PLANNING AMMENDMENT APPLICATION re 421/0027/02
EXTRA WINDOW AS SHOWN IN RED

AMENDMENT RECORD SHEET - LIVE APPLICATION

**REF: PROPOSED CHANGE OF USE OF COMMERCIAL AREAS TO RESIDENTIAL
ALONG WITH ELEVATIONAL ALTERATIONS AND EXTENSION AT NO 1 WEST ROAD
& WESTGATE HOUSE, WEST ROAD, TYDD GOTE, WISBECH.
FOR. MR.& MRS. J. BAKER.**

**Change of Use of Commercial Areas
to Residential along with Elevational
Alterations and Extension at
No1 West Rd & Westgate House,
West Road, Tydd Gote, Wisbech.
For. Mr. & Mrs. J. Baker.**

FRONT ELEVATION

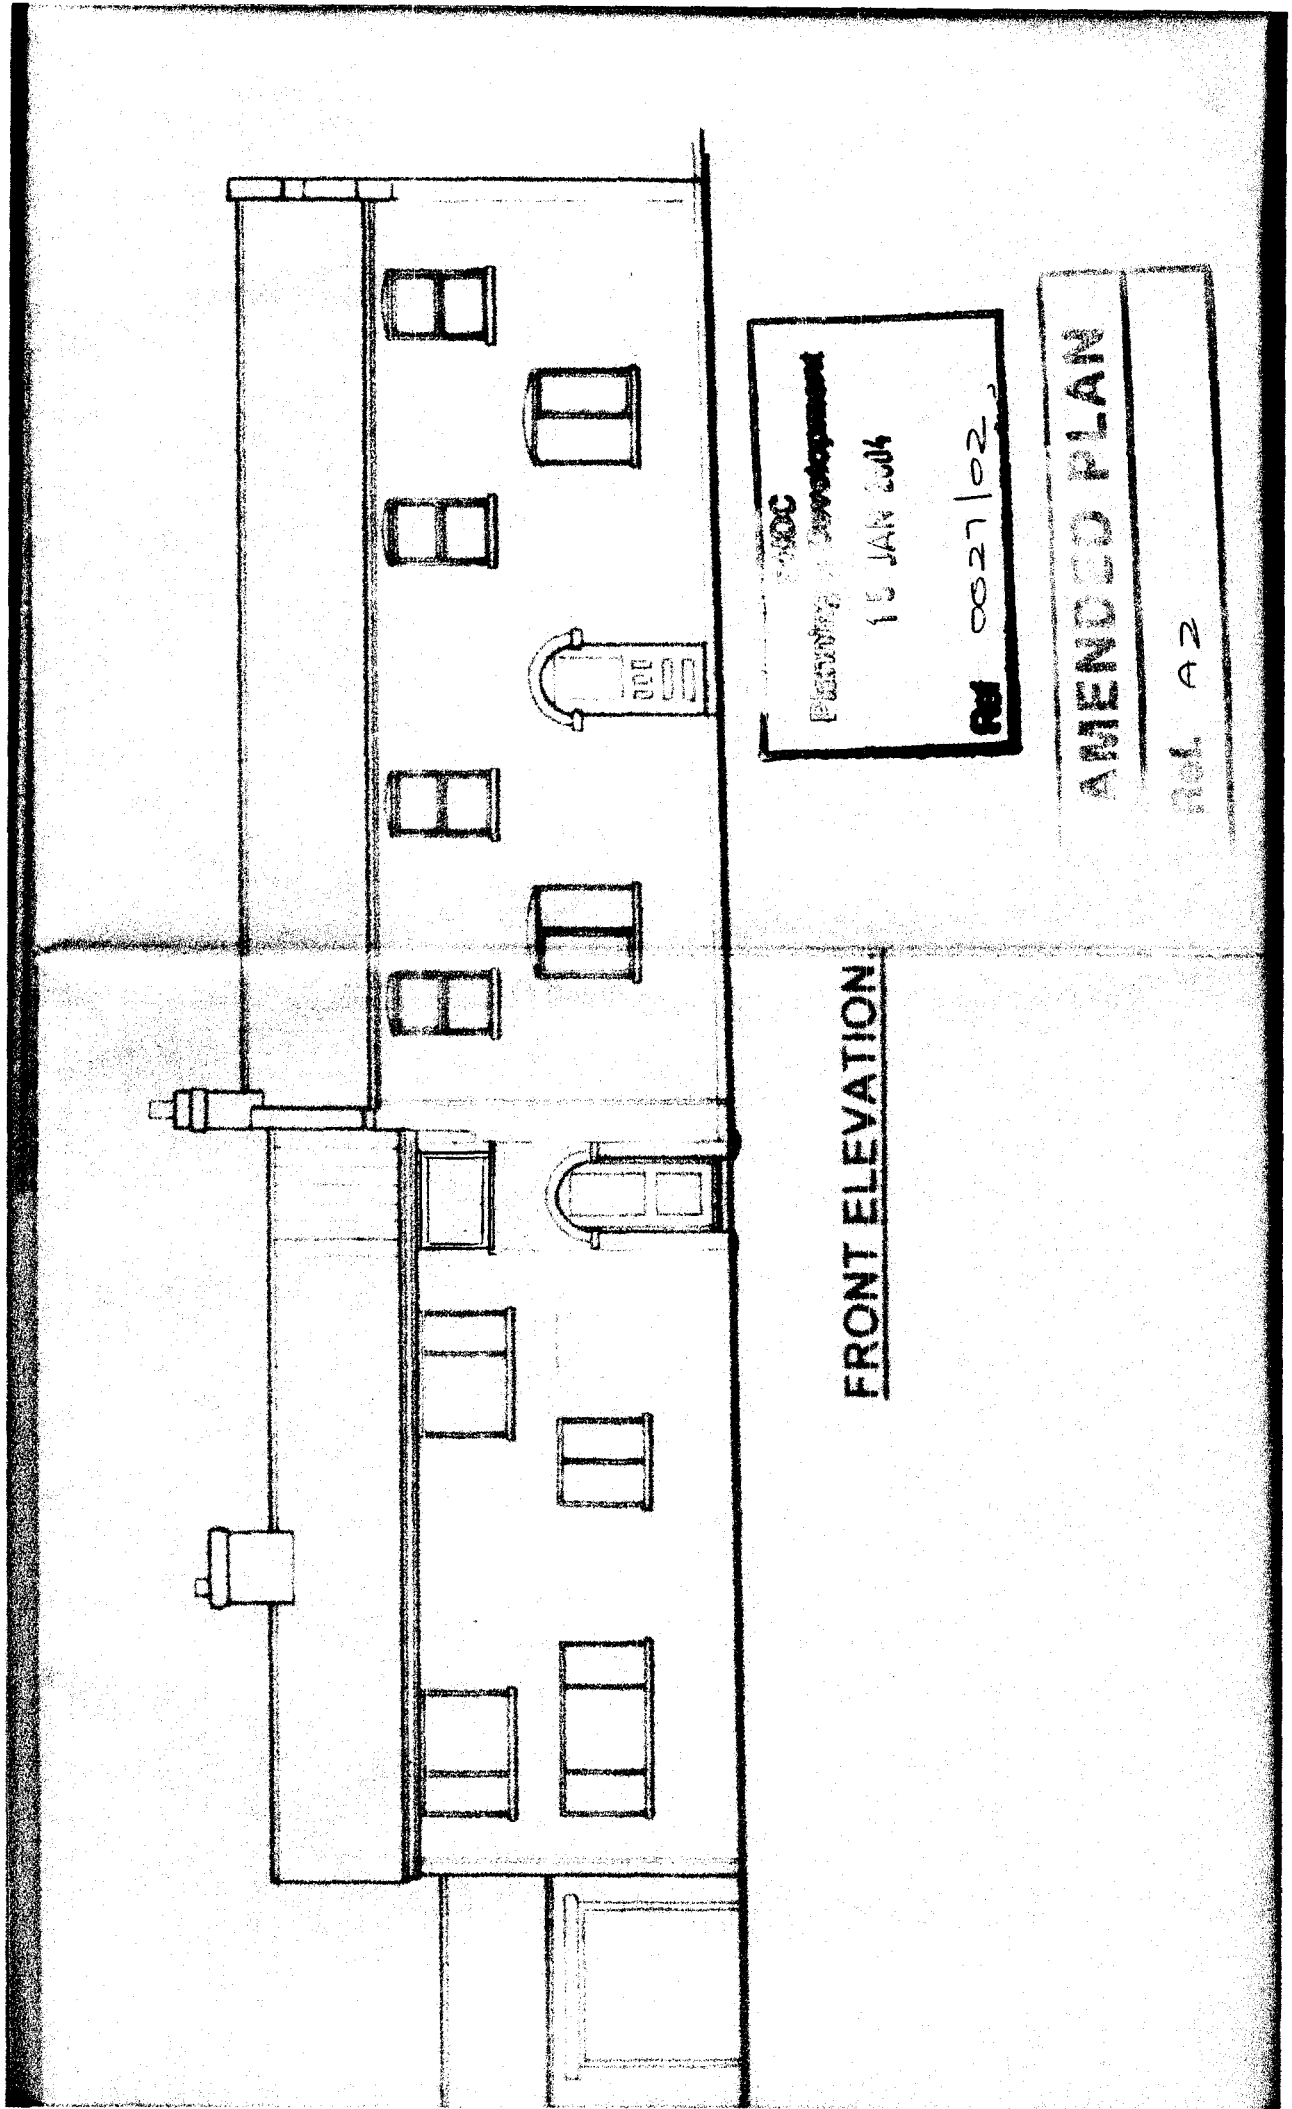
PLANNING AMMENDMENT APPLICATION re H21/0027/02.
EXTRA WINDOW AS DRAWN IN RED

FRONT ELEVATION.

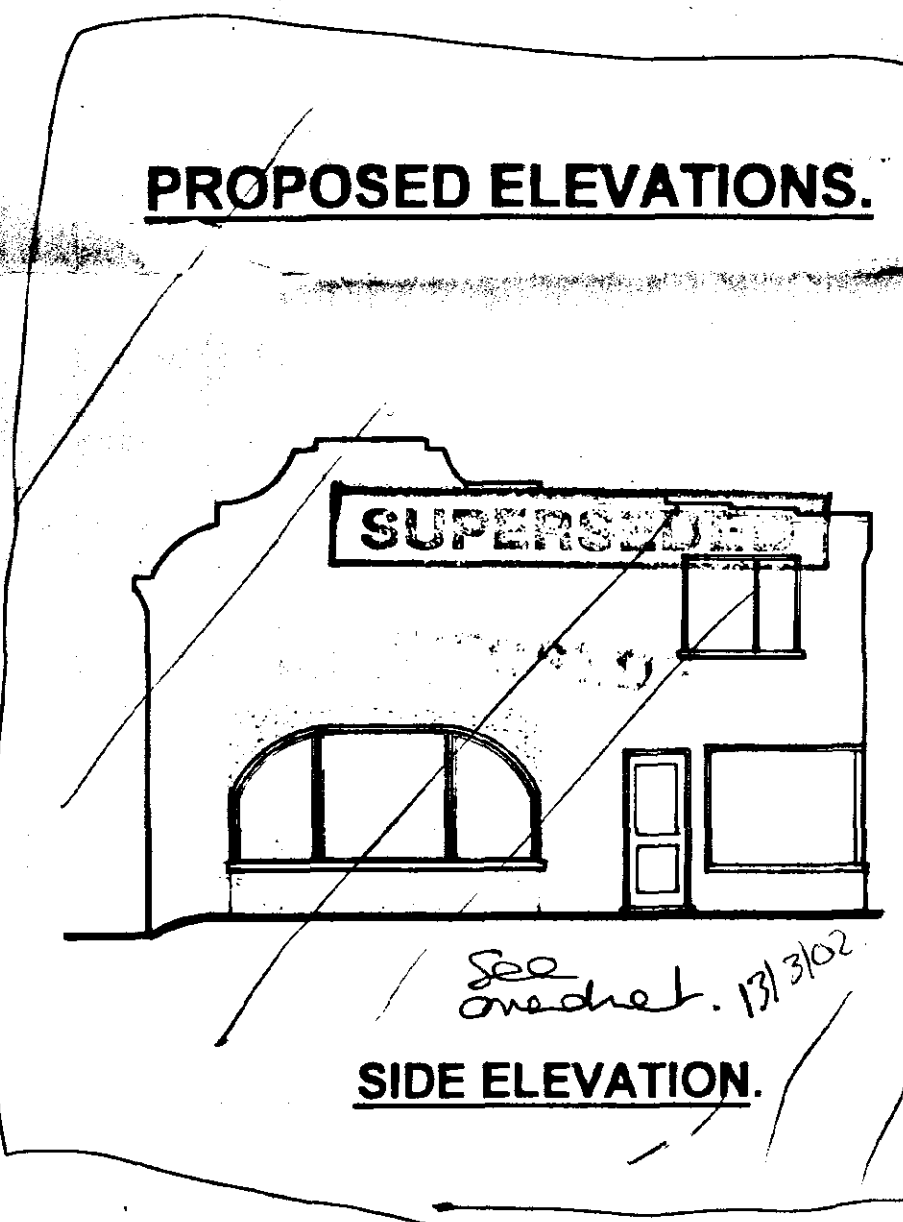
front window amendment.
